National Transportation Safety Board

Safety Recommendation

In reply refer to: H-01-28

LOCATIONS WITH SEVERE DAMAGE

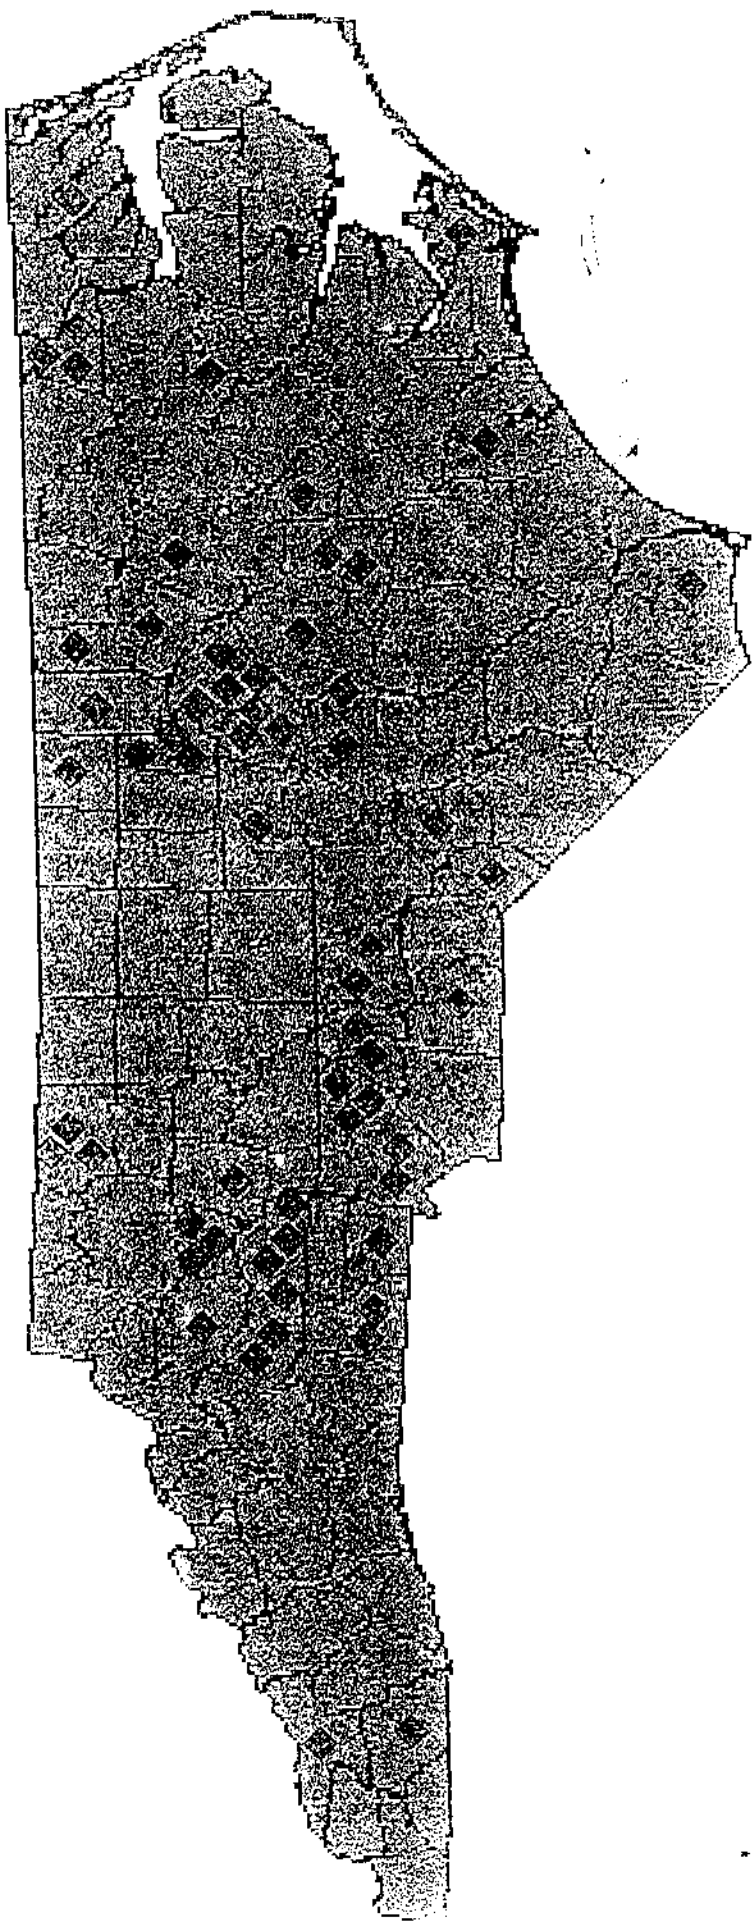
Although the presence of the guardrail system had little effect on the severity of the accident, Safety Board investigators were concerned that the extensive termite damage found in some of the guardrail posts could have compromised the safety of the smaller private passenger

In summary, based upon our investigation of guardrail installations with wood posts, we recommend that the standard be modified to specify steel guardrail posts with recycled plastic offset blocks. Marie Sutton advises that numerous manufacturers of recycled plastic offset blocks are approved who should be able to meet the demand. The Chief Engineer's Office and the Division Engineers have reviewed this information and are in full support of this recommendation.
